REQUEST FOR LETTER OF MAP REVISION

Ford / Conquistador

Subject: Addendum #1 to the Technical Drainage Study for
LOMR for Ford/Conquistador
H T E #06-26038

TO: Chris O. Stone, P.E. *COS*
FROM: Isabel Pennington *IP*
OFFICE: Las Vegas
DATE: June 12, 2006
SUBJECT: WILLDAN / Clark County Development Services Dept. Plan Review Contract
Technical Drainage Study for Outfall of Upper Blue Diamond Detention
Basin Adjacent to the future Ford/Conquistador Residential Subdivision
(5267)
Study Dated: May 26, 2006
Location: East of the outfall of the Upper Blue Diamond Detention Basin and
north of Ford Avenue
(Sec. 18, T. 22 S., R. 60 E.)
HTE # 06-26038
Prepared by Triton Engineering

FIGURE ADD1 - 3

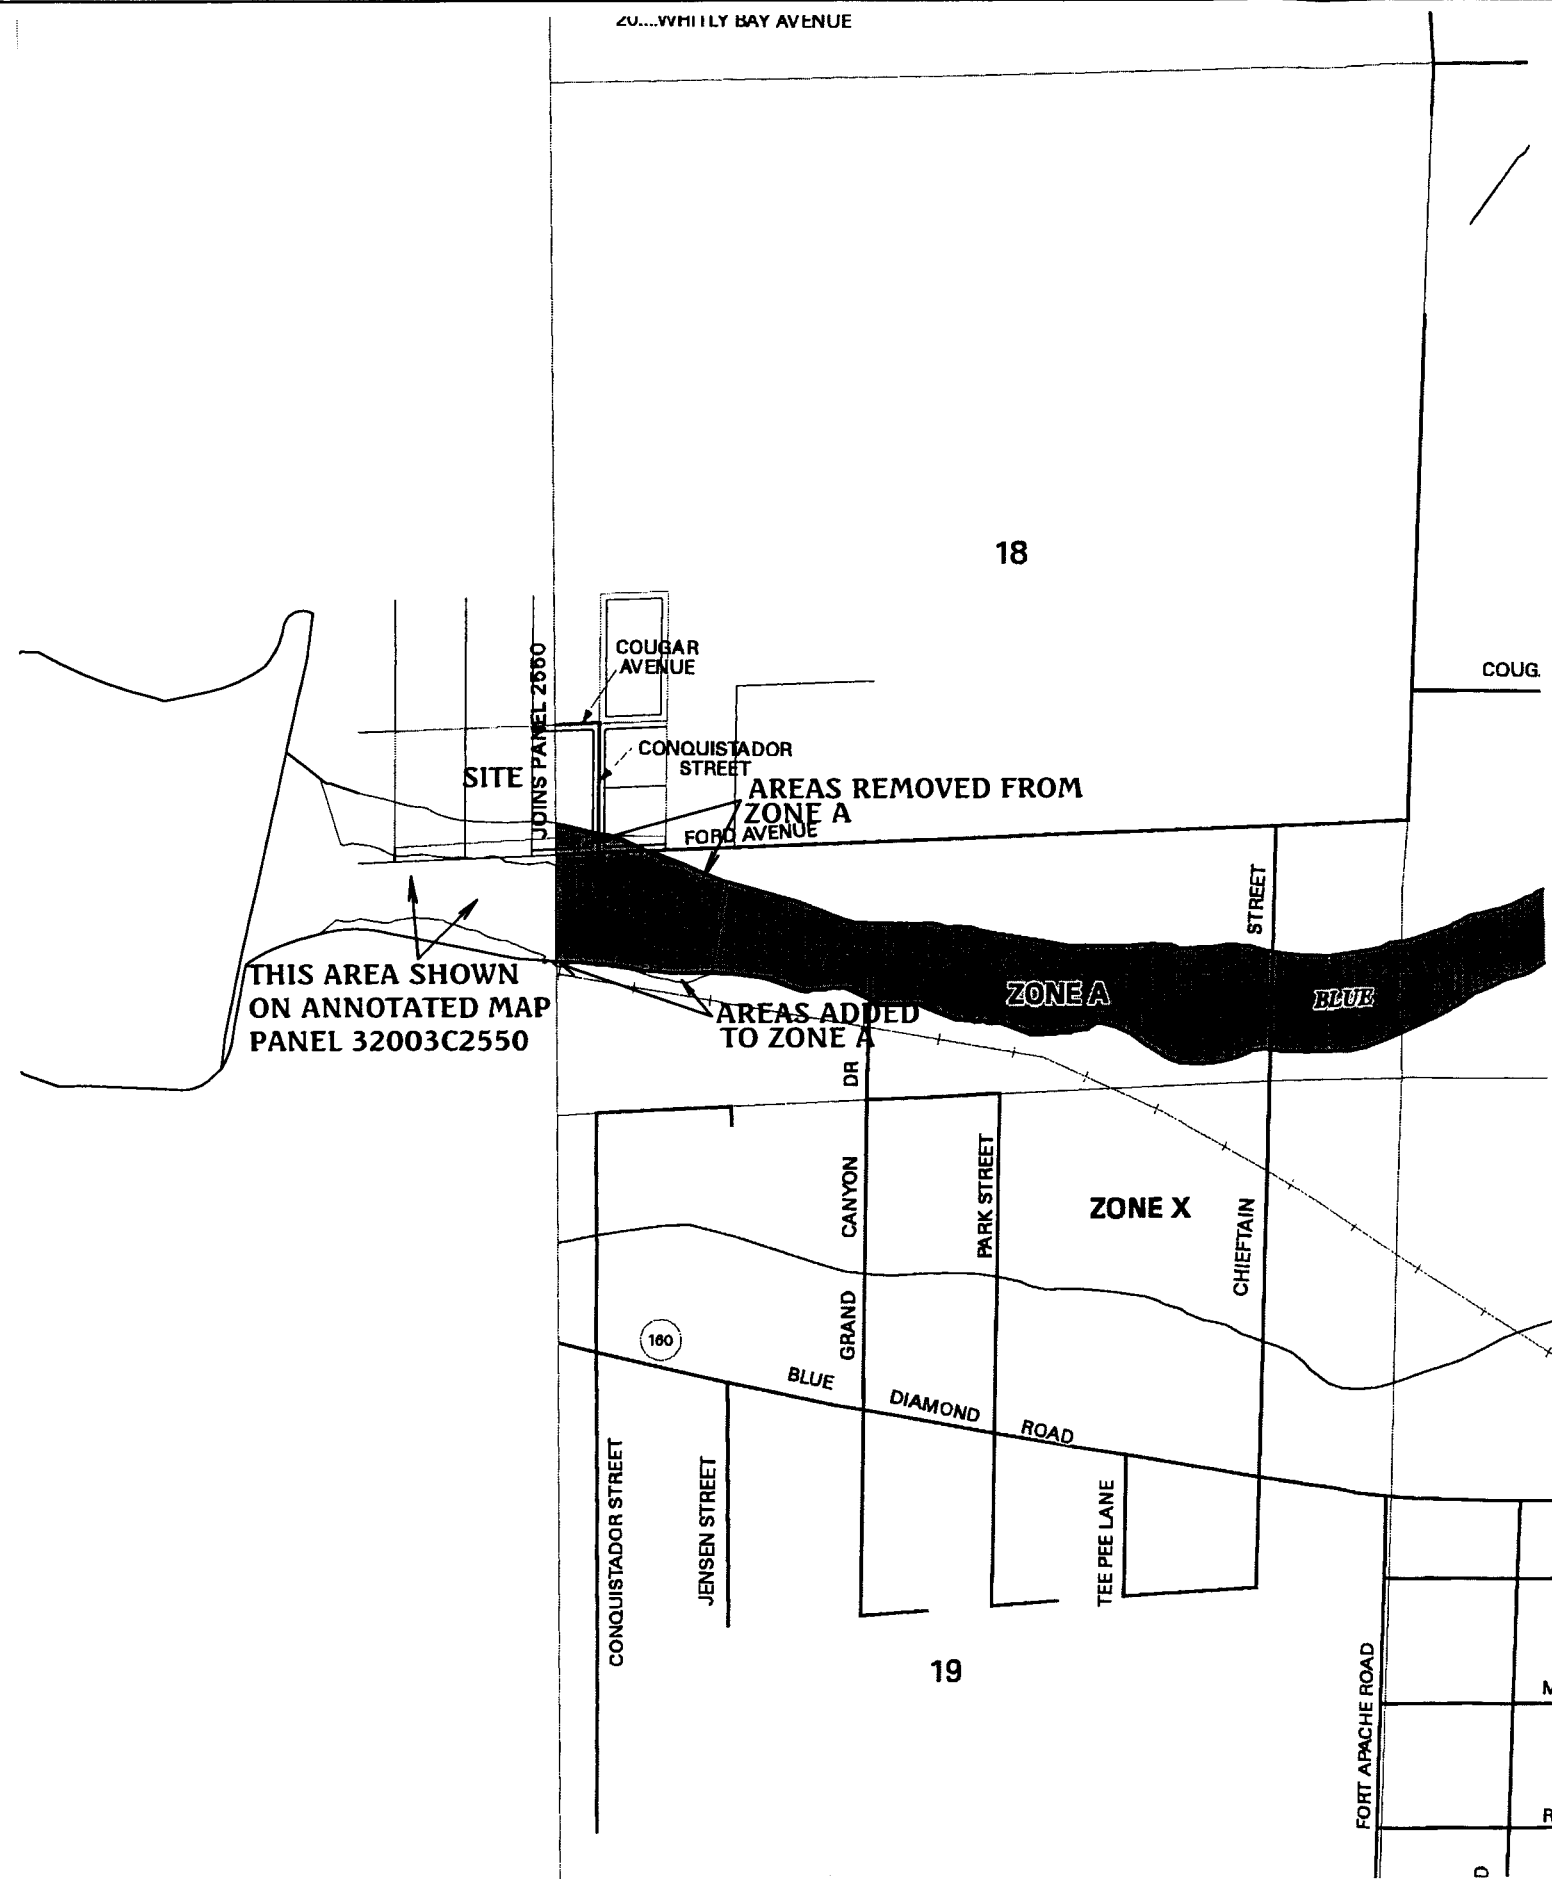
- 9. An annotated FIRM Map must be provided and the proposed flood zone delineation added to Figures D-1 (A-E);**

The annotated FIRM Maps have been added to this submittal as Figures ADD1-3 and ADD1-4. Figure D-1 (A-E) has been replaced with Figure ADD1-2, which provides all of the pertinent topographic information, cross sections, and proposed flood zone delineation.
